Re: Atlanta Zonolite Place Site – Final Grading Plan Addendum

This Addendum memorializes agreement between Grace and DeKalb County regarding the final grading plan for the Atlanta Zonolite Place site (attached).

**ZONOLITE PARK**  
STORMWATER MANAGEMENT DESIGN  
#47 ZONOLITE PLACE, ATLANTA, GA 30307  
**GRADING PLAN**

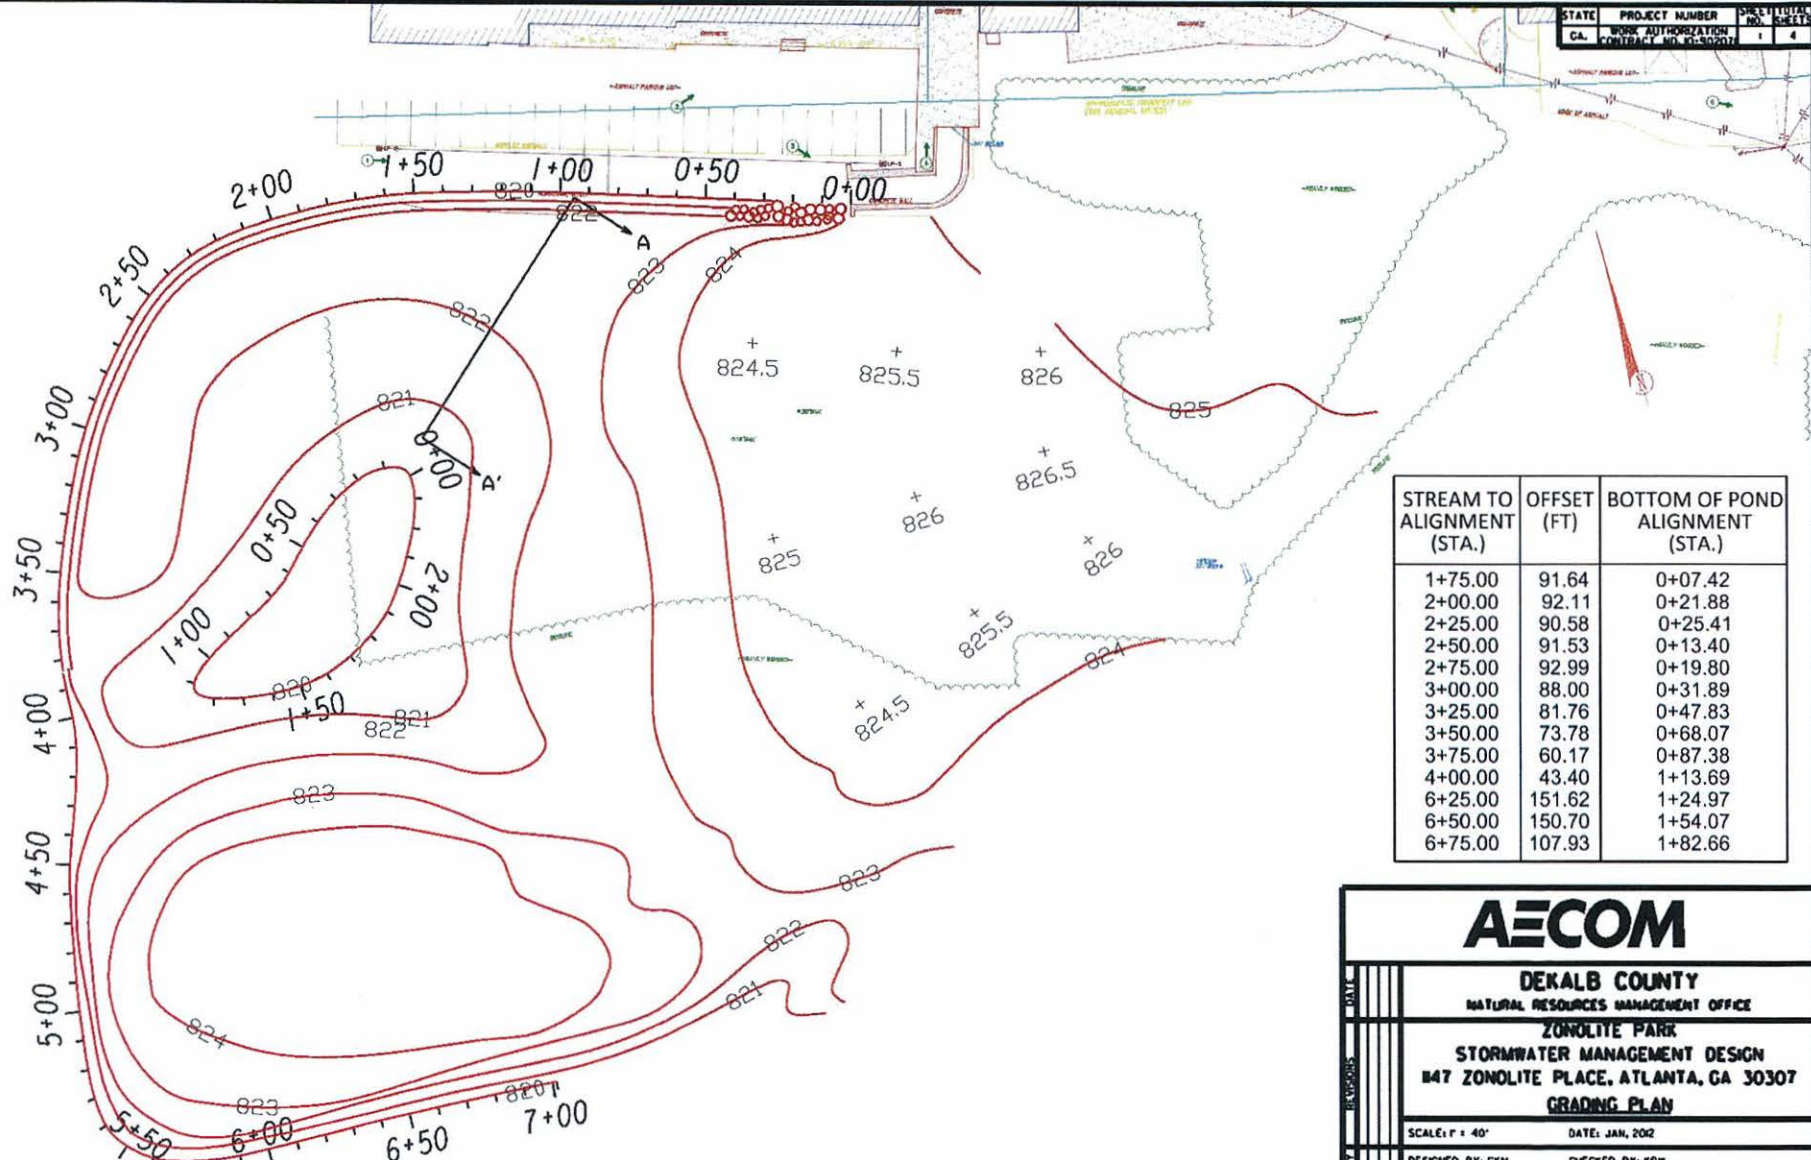
Grace will install 40 feet of riprap (large rock) on the ditch/creek berm as indicated on the final grading plan.

The entire excavation site will be hydroseeded, followed by installation of a single-sided, erosion control straw mat around the creek side of the newly installed berm (north, west, and south sides of the excavation area).
